## ***Interactive comment on “A geophysical analysis of hydro-geomorphic controls within a headwater wetland in a granitic landscape, through ERI and IP” by E. S. Riddell et al.***

**E. S. Riddell et al.**

Received and published: 9 August 2010

Anonymous Referee #3

Fig. 2.

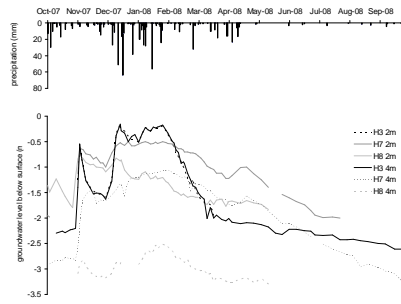
Page 1984. The nomenclature of the piezometers has been changed in Fig 2. Fig 9 (Fig. 2 attached) and in the discussion. A few sentences are included in reference to the deeper piezometers and how the failure of the deeper piezometer at H8 to recharge to a shallow level as the 2 m piezometer suggests at lack of recharge – and a partial separation of near surface groundwater to that of a slightly deeper water table. The units of display have been changed from mm to m (referring to a comment by Anonymous Referee #2).

Fig. 2: Now Fig 3. Has been left as a separate figure but contains a simplified geology, better nomenclature for hydrometry stations, and coloured lines for transects.(see comment to Anonymous Referee #2)

Fig 8: Now Fig 9. Name convention in accordance with Fig 3 and in metre units rather than millimeters.

Fig. 3.

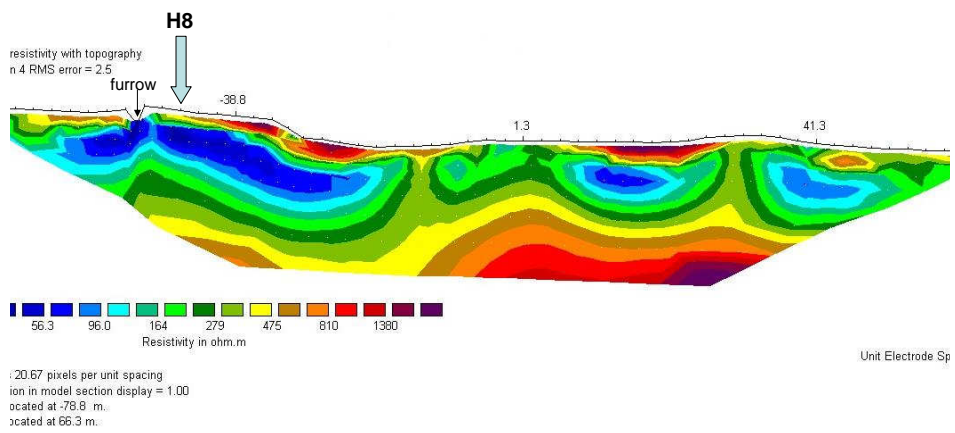
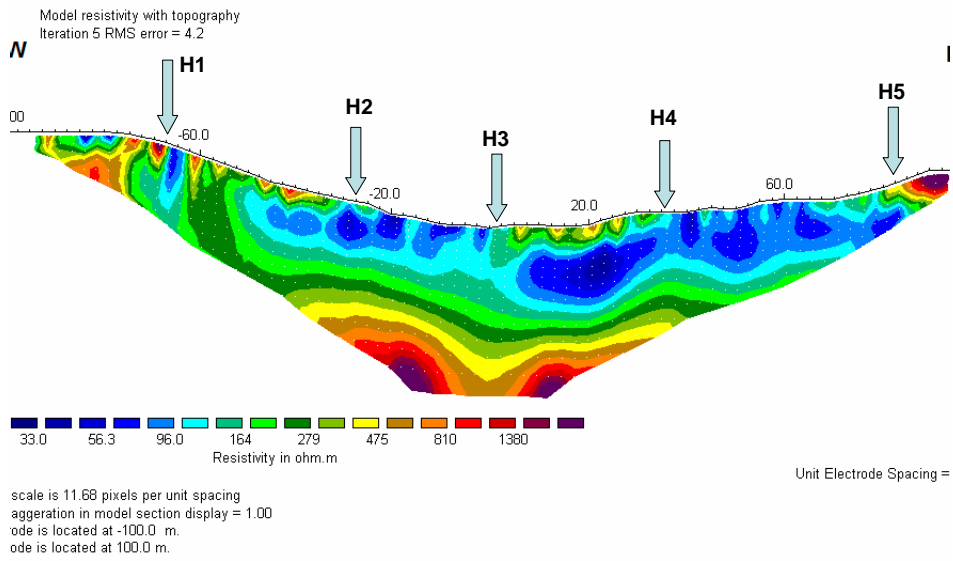
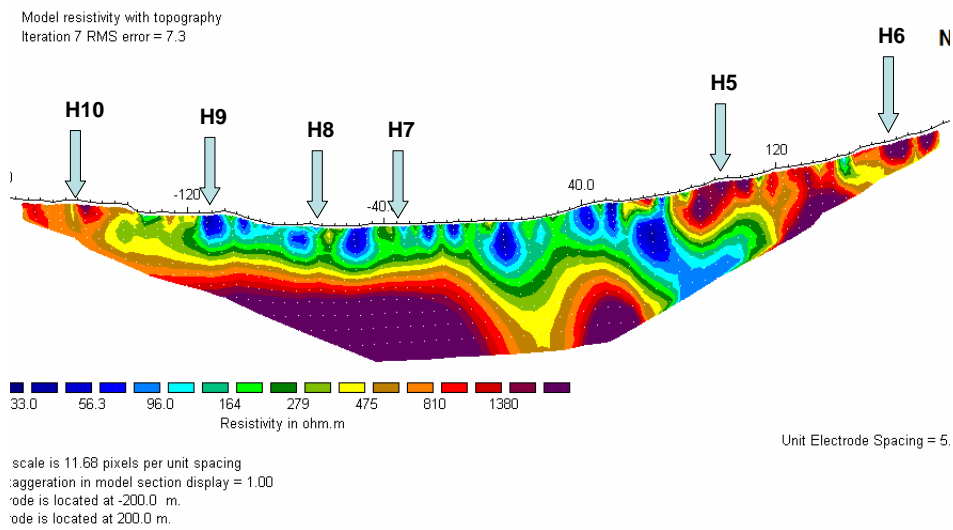
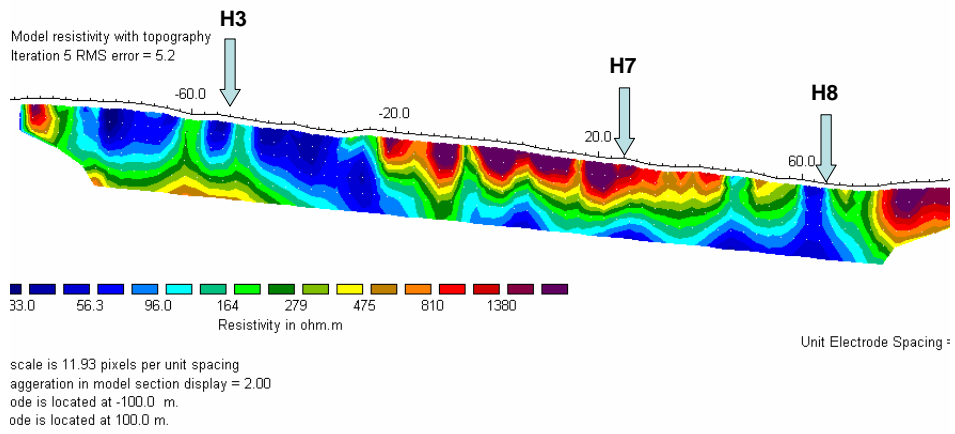
Fig 4-7: Now Figs 5-8 in manuscript (Figs 3-6 attached). Positions of hydrometry stations have been superimposed

Fig. 7.

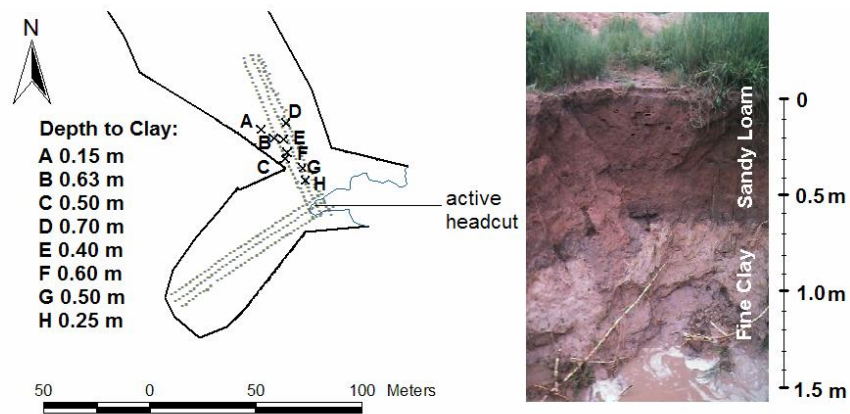
Fig 15: Now Fig 16. Auger depths added, a depth scale for headcut and description of soil form added (Fig 7 attached).
